CITY OF KIRKLAND
 123 FIFTH AVENUE • KIRKLAND, WASHINGTON 98033-6189 • (425) 828-1257
DEPARTMENT OF PLANNING AND COMMUNITY DEVELOPMENT
ADVISORY REPORT
FINDINGS, CONCLUSIONS, AND RECOMMENDATIONS

Date: January 6, 2004

File: Stacy Property Preliminary Subdivision and Innovative Housing Project, File No. S-IIB-03-60

ATTACHMENT 2P
S-IB-03-60

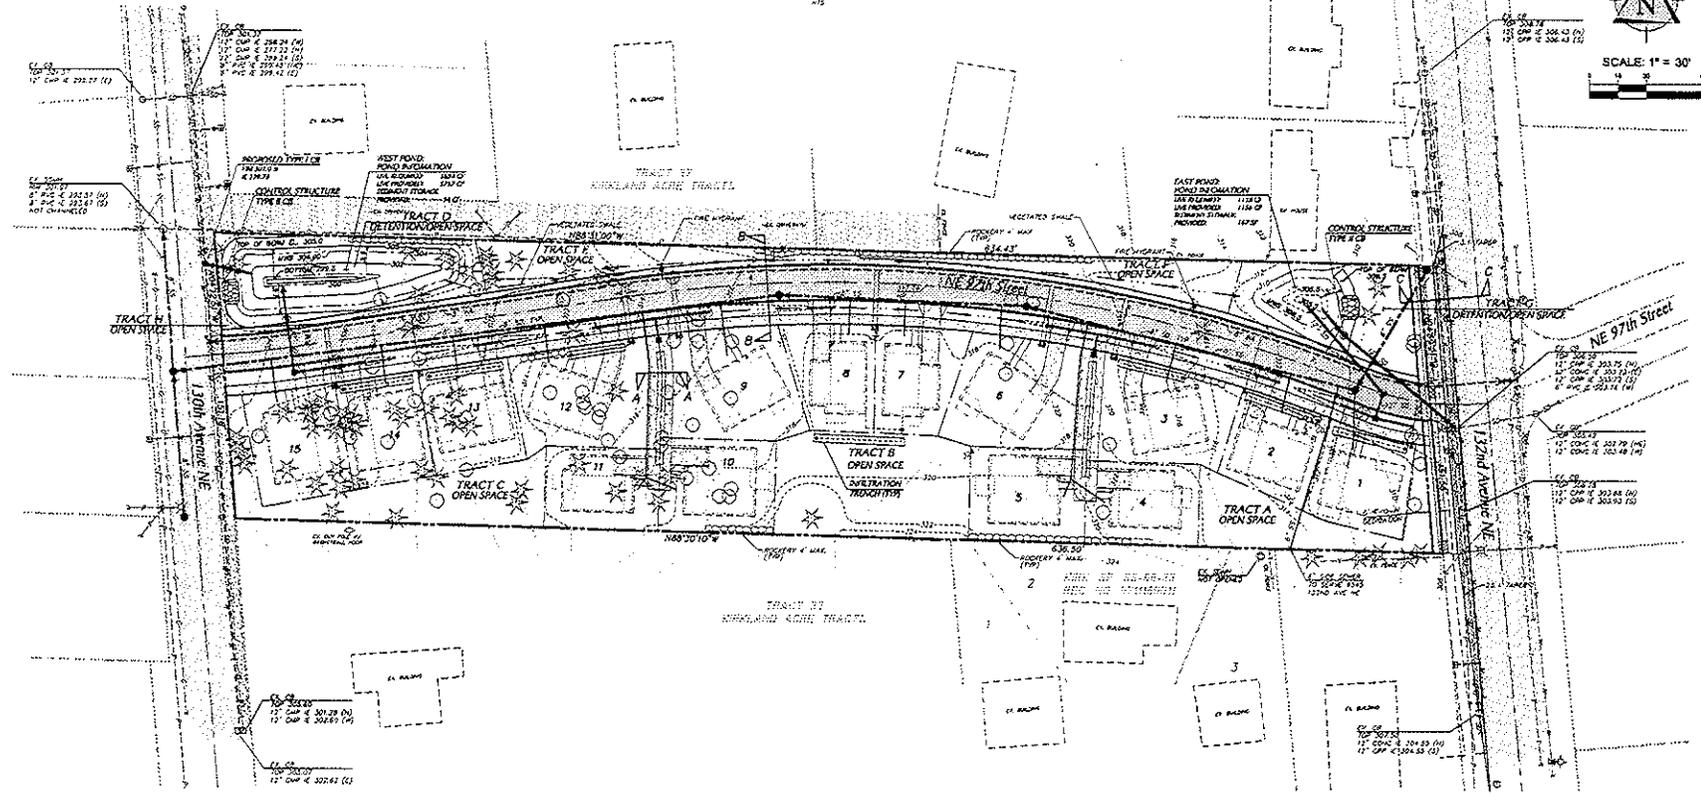
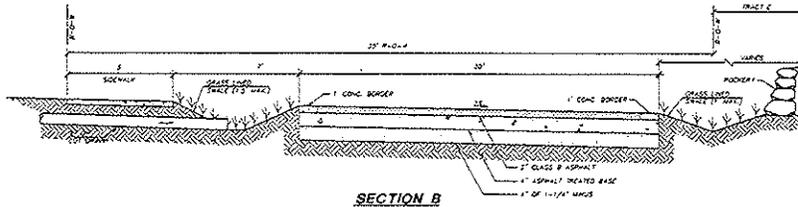
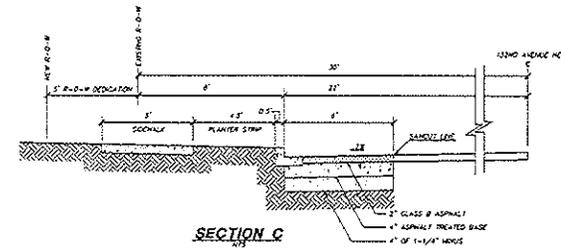
Provide temporary and permanent storm water control per the 1998 King County Surface Water Design Manual. The preliminary storm plans, which include a combination of infiltration, swales, a rain garden, and a detention pond, have been reviewed and approved by the City's Surface Water Engineer. Additional refinement of the design and submittal of the final calculations will be necessary.

DATE: 02/15/03
PROJECT: STACY PROF
DRAWN BY: STACY PROF
CHECKED BY: STACY PROF
PROJECT LOCATION: STACY PROF
FIRST SUBMITTAL DATE: 2/15/03
SCALE: 1" = 30'

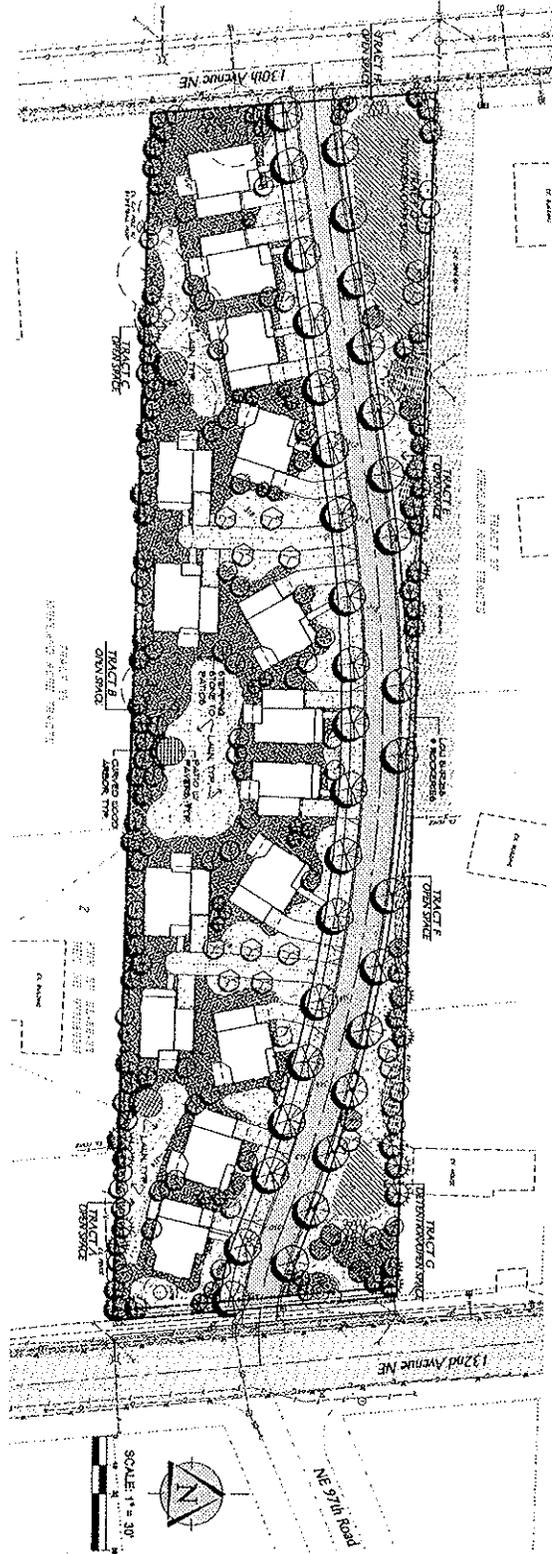
The driveway for the lot/house closest to 132nd Ave. NE and 130th Ave. NE shall be located on the side of the house farthest from the street. The site plan shows the driveways on the wrong side of the house.
